## NRC RAI

### Response L-0998 Outline:

**Levy Nuclear Plant Units 1 and 2**  
**COL Application**  
**Part 2, Final Safety Analysis Report**

Figure RAI L-0998-2: Comparison of scaled GMRS based on EPRI-SOG/UCSS model with full CAV with the GMRS based on the CEUS SSC model with modified CAV

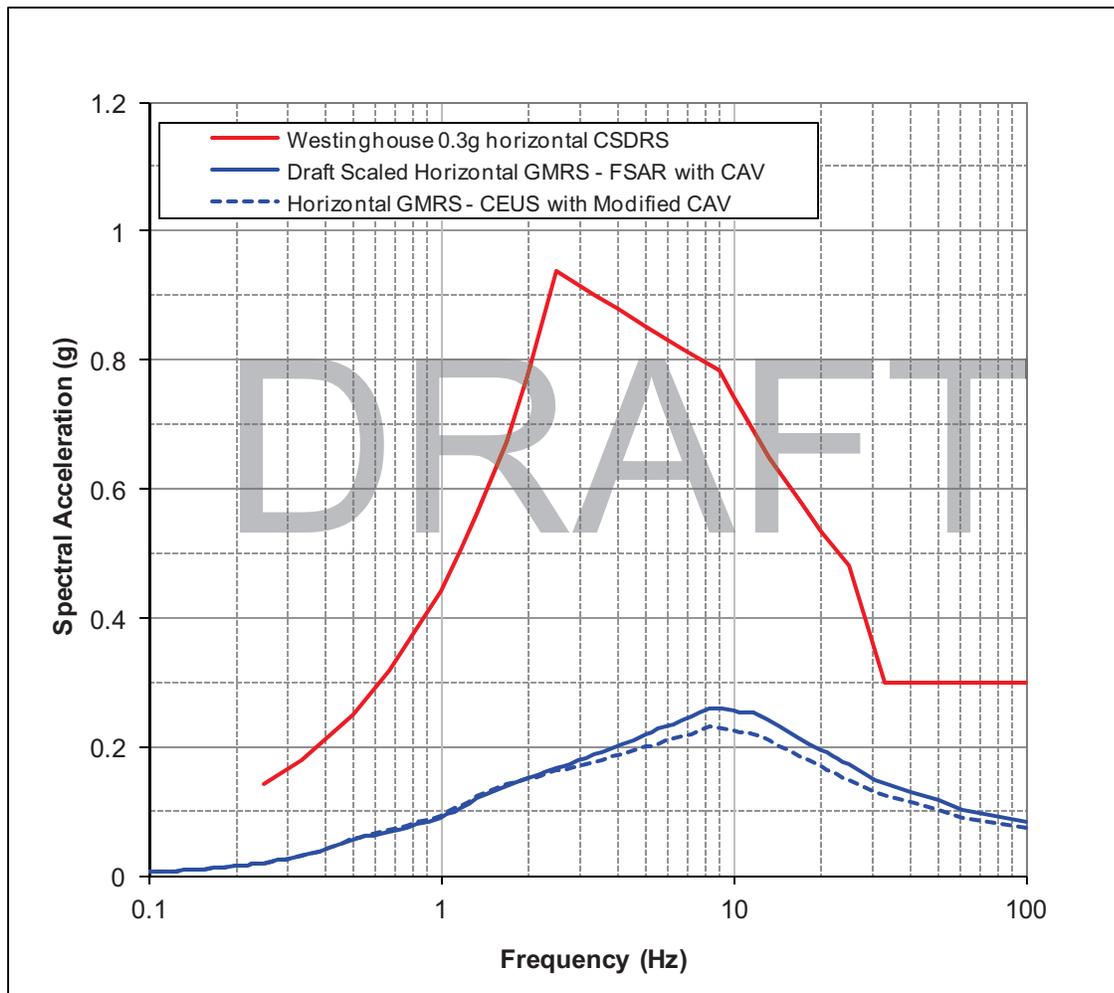
Evaluate the seismic hazard at your site against current NRC requirements and guidance and, if necessary, update the design basis and structures systems and components important to safety to protect against updated hazards (seismic portion only – of detailed Recommendation 2.1 – Enclosure 7 of SECY-12-0025).

As shown in Figures RAI L-0998-2 and RAI L-0998-3, both the CEUS SSC GMRS and the PBSRS are enveloped by the AP1000 CSDRS. As [stated](#) above, the CEUS SSC LNP site specific floor response spectra (FRS) at the six key locations are bounded by the CSDRS FRS and the maximum bearing pressure is less than the 24 ksf design value. Thus, LNP site unique foundation conditions and CEUS SSC ground motions do not lower the High Confidence Low Probability of Failure (HCLPF) values calculated for the certified design.

Figure RAI L-0998-2 compare the scaled GMRS based on the EPRI-SOG/UCSS model with full CAV with the GMRS based on the CEUS SSC model with modified CAV. The scaled GMRS based on the CEUS SSC is lower than the GMRS based on the EPRI-SOG/UCSS model with full CAV except for frequencies between 0.2 and 2 Hz where the maximum increase is approximately 4 percent at 1 Hz.
